City of Phoenix

Staff Report: Z-10-18-8

May 1, 2018

Commercial and medical uses

FEB 12 2018

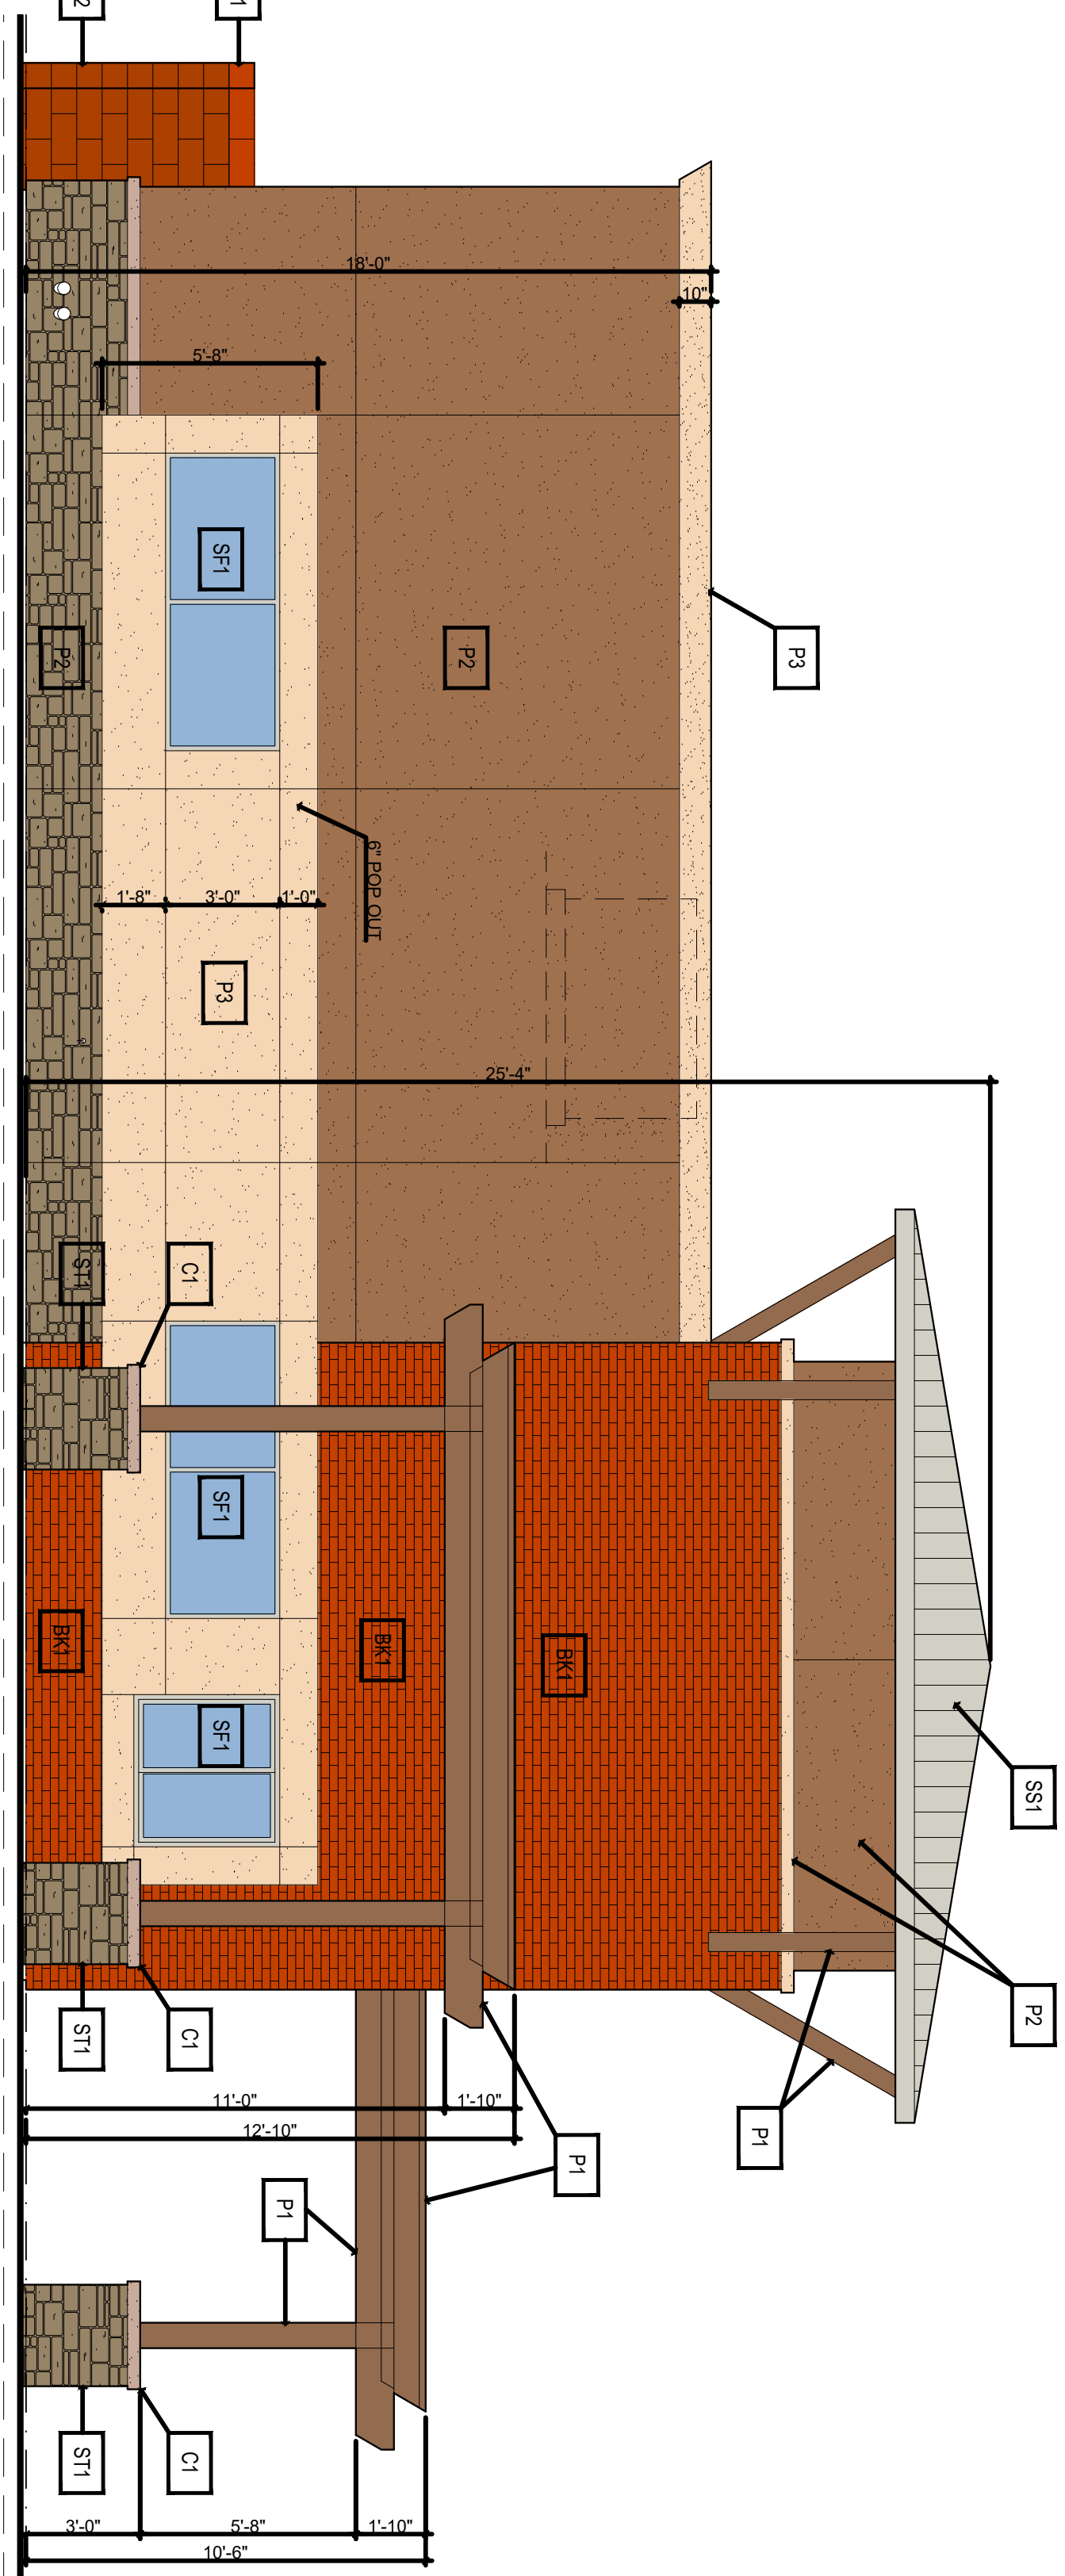
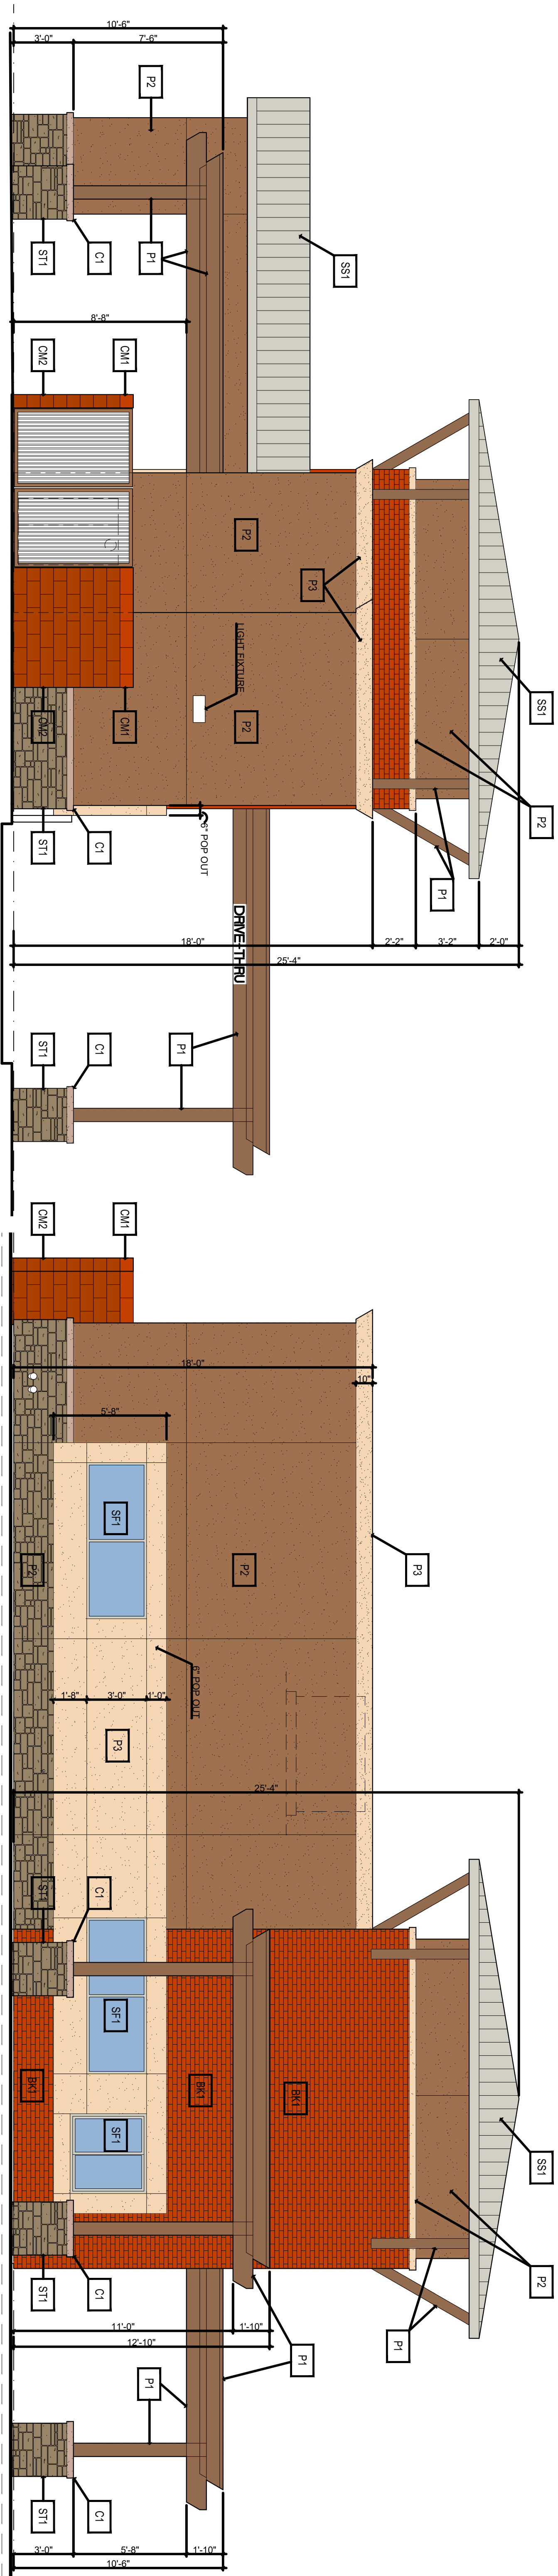
The conceptual building elevations depict a commercial drive-through restaurant at one-story and 30 feet in height. The building elevations contain a variety of building materials including cultured stone, brick, and colored concrete. Roof materials are varied and consist of wooden awnings, metal, and a variety of parapet materials and architectural features. Building colors are varied with at least four exterior colors.

- Stipulation #1 requires general conformance to these elevations.
- Stipulation #1.a. requires that pitched roof elements shall be incorporated in all buildings.
- Stipulation #1.b. requires that all building elevations, including those facing or visible from the Western Canal, contain architectural embellishments and detailing. This stipulation is intended to ensure that equal attention is paid to the elevations facing the Western Canal and visible from adjacent properties. These features may include textural changes, pilasters, offsets, recesses, variation in window size and location, and/or other overhang canopies.

1. The development shall be in general conformance with the elevations date stamped February 12, 2018, as modified by the following stipulations and approved by the Planning and Development Department:

- a. Pitched roof elements shall be incorporated in all buildings.
 - b. All building elevations, including those facing or visible from the Western Canal, shall contain architectural embellishments and detailing such as textural changes, pilasters, offsets, recesses, variation in window size and location, and/or other overhang canopies.
